Brief Design and Access Statement

Minor Material Amendment

Change of Single Wind Turbine Previously Consented

At Rainsbutt Farm, Crowle, Scunthorpe,

Figure 2: Indicative elevation of Enercon E53 wind turbine with 50m hub height.

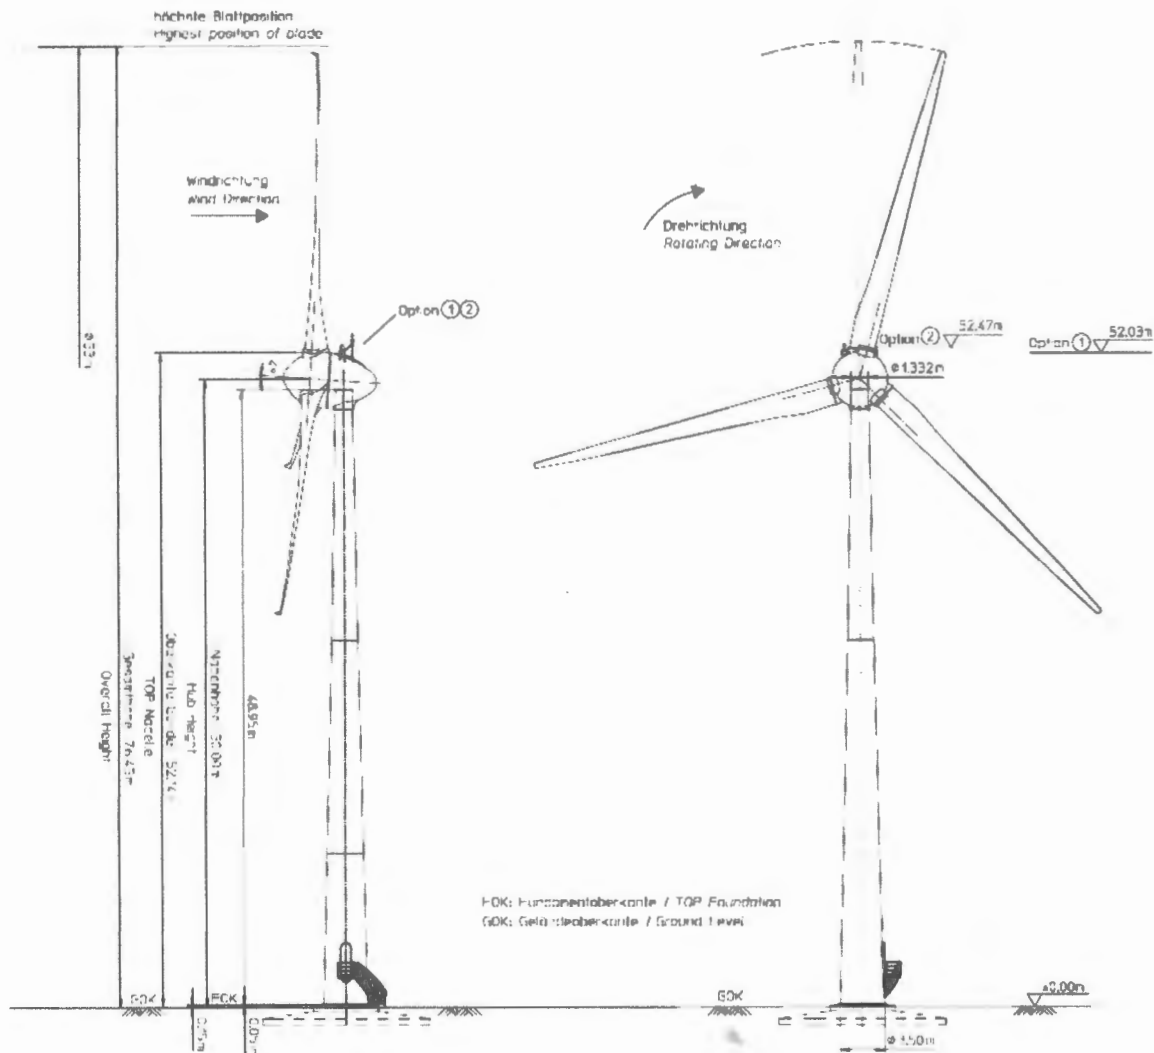
This Design and Access Statement is submitted in conjunction with a set of plans for the proposed change of turbine type from the previous consented EWT 54 single wind turbine with a hub height of 50m and a maximum tip height of 79m (Planning Ref: PA/2014/059) to an Enercon E53 single wind turbine with a hub height of 50m and a maximum tip height of 77m.

In terms of the height difference of the previous consented wind turbine; EWT 54 single turbine with a hub height of 50m and a maximum tip height of 79m (Planning Ref: PA/2014/059), the proposed Enercon E53 single wind turbine will have a hub height of 50m and a maximum tip height of 77m. Therefore, it is considered that the proposal is lower in height by 2m and has less of a visual impact compared with the consented turbine, which is considered a positive change.
